Docket Item # 7  
BAR CASE # 2018-00095

BAR Meeting  
April 4, 2018

**ISSUE:** Alterations

**LOCATION:** 813 South Columbus Street

Figure 2: Back of property, 813 South Columbus boxed in red, 819 South Columbus converted French doors into windows, boxed in yellow.

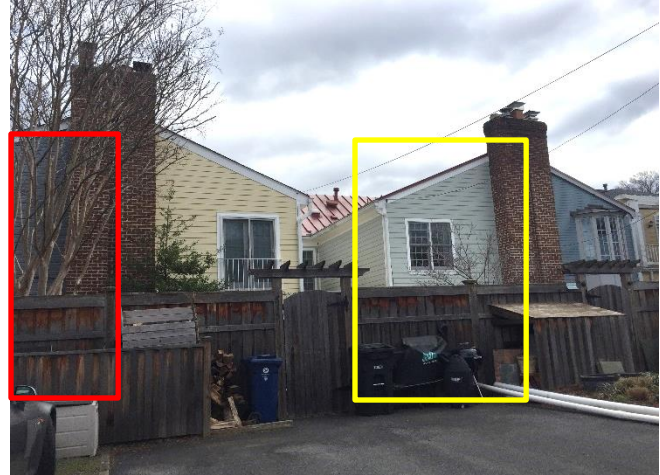
Staff supports the proposed conversion of the French doors into a pair of double-hung windows because it is compatible with the other townhouses in this row (Figures 1-3). Most of the project (siding, gutters, door replacement, window replacement) could be administratively approved, but the change from doors to windows on the rear elevation is beyond a repair and requires approval by the BAR at a full hearing. The proposed alteration of the French doors into double-hung windows will not be visible from South Columbus Street but rather from the public alley and parking lot behind the 800 block of South Columbus Street and South Alfred Street.

The alteration is compatible in style, material and fenestration with the existing townhouses. The French doors were original to the design approved by the Board in 1979. Many of these townhouses have either converted their French doors into windows or added a porch to use the French doors (Figures 1-3). Although the proposed alteration departs from the original design, the double-hung windows are compatible with the architectural character of the townhouse and its neighbors.

The *Design Guidelines* state that “new and replacement windows should be appropriate to the historic period of the architectural style of the building.” The new double-hung windows will match the configuration of the other windows in the townhouse and will be similar to 819 South Columbus (Figure 2). These six-over-six, double-hung windows are appropriate for the Colonial Revival style of the building.

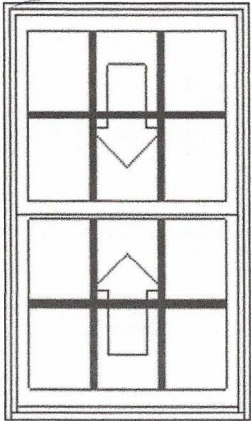
The proposed aluminum-clad wood windows comply with the *Window Policy* with the change of the Low-E glass from Low-E 366 to Low-E 272, in order to comply with the *Alexandria Replacement Window Performance Specifications*: “All glazing must be clear, non-reflective and

without tint. Low-E (low emissivity) glazing is encouraged for energy conservation but the glass must have a minimum 72% visible light transmission (VLT) with a through-the-glass shading coefficient between 0.87-1.0, and reflectance of less than 10%. Low-E 272 generally meets these criteria.”

Staff recommends approval as submitted with the following condition:

1. As required by the BAR's adopted window policy, all glazing must be clear, non-reflective and without tint. Low-E (low emissivity) glazing is encouraged for energy conservation but the glass must have a minimum 72% visible light transmission (VLT) with a through-the-glass shading coefficient between 0.87-1.0, and reflectance of less than 10%. Low-E 272 generally meets these criteria.
